Marine Scotland - Licensing Operations Team **Scoping Opinion**

**SCOPING OPINION FOR THE PROPOSED SECTION 36 CONSENT AND
ASSOCIATED MARINE LICENCE APPLICATION FOR THE MORAY EAST
OFFSHORE WINDFARM ALTERNATIVE DESIGN PARAMETERS.**

Figure 2-1: Approach to defining the scope of the EIA

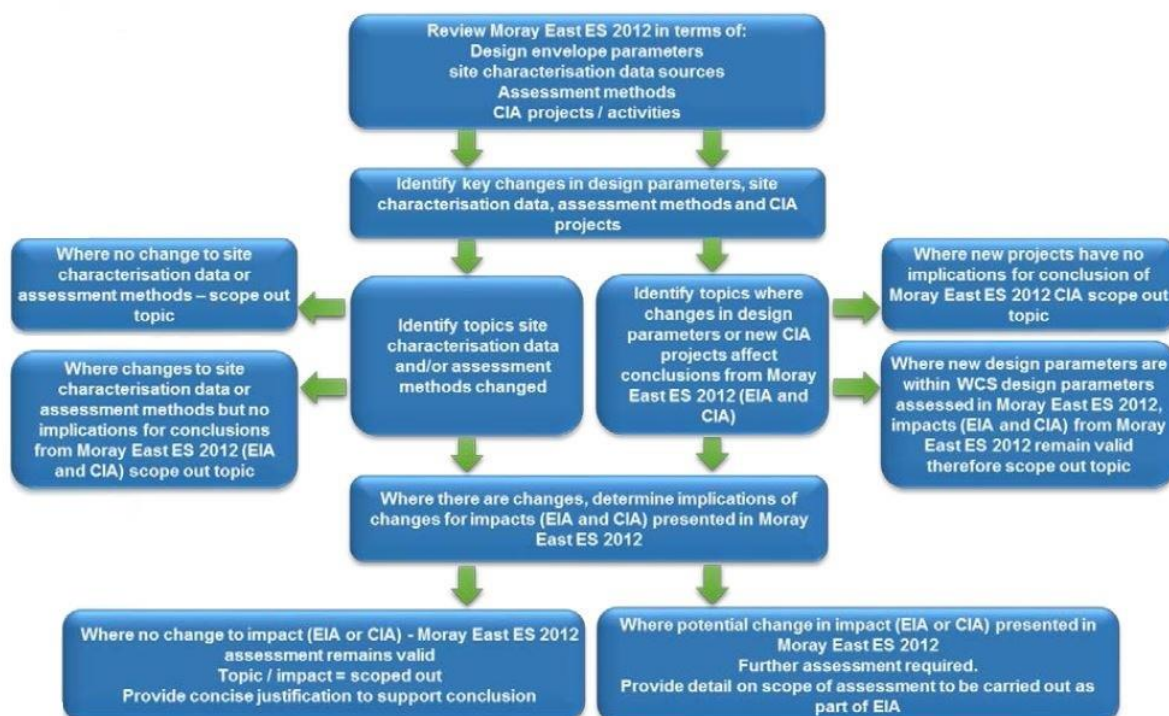
MS-LOT agree with this approach, MS-LOT highlight that where significant effects were identified within the Moray East ES 2012 these must be reported in the ES for the current project, even though there is no requirement to update the previous assessment based on the approach above.
